CORPORATION
Crystal River Unit 3
Docket No. 90-302

May 15, 1995
3F0595-14

Subject: Crystal River Unit 3 Fifth Tendon Surveillance, Additional
Information

FIGURE 6.1 R2

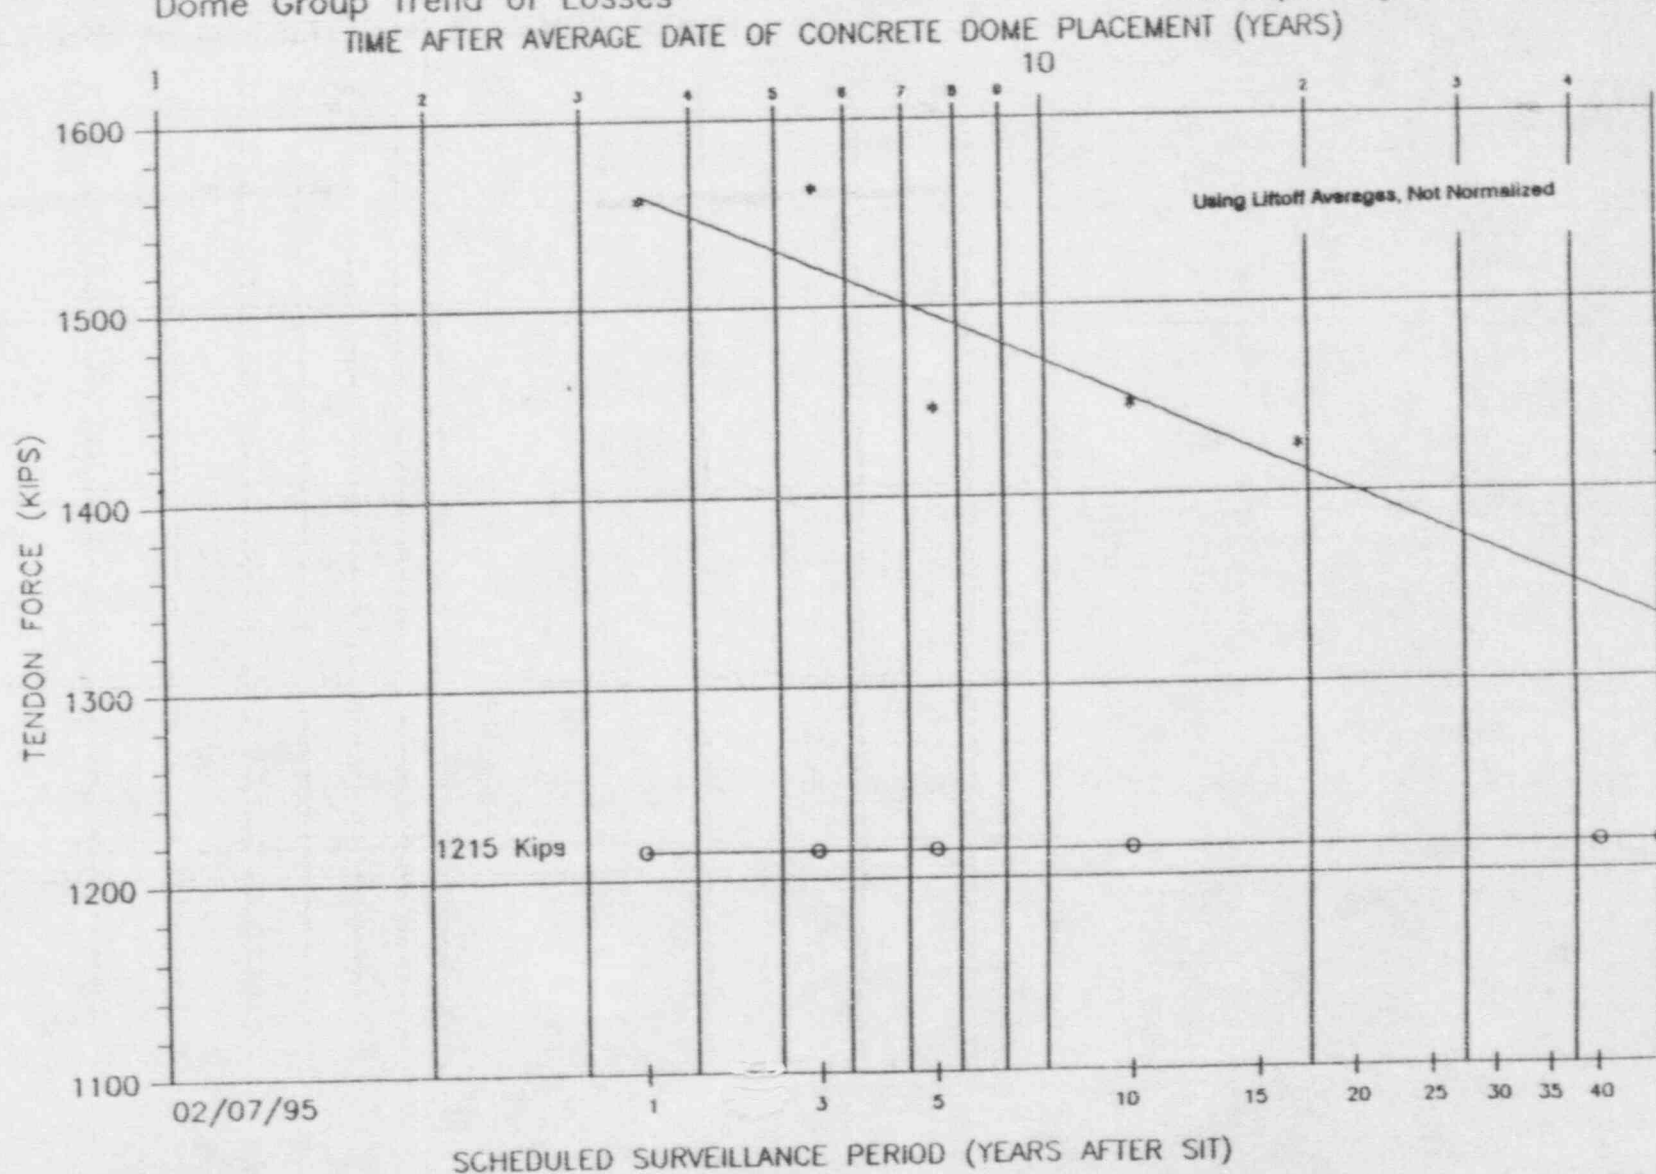
FPC stated in its response to question No. 2 that the regression analysis based on individual data is mathematically identical to that based on average value. The staff has performed the two cases as shown in the attachment. The trend line for the two cases have different slopes and the one based on average values gives a less conservative trend. Please explain.

Although the difference between the results of the two curves is not significant they are not mathematically identical.

Dome Figures 6.1 vs. 6.1R2	Lower slope without normalizing factor
Hoop Figures 6.2 vs. 6.2R2	Slightly lower slope <u>with</u> normalized data
Vertical Figures 6.3 vs. 6.3R2	Slightly lower slope without normalizing factor
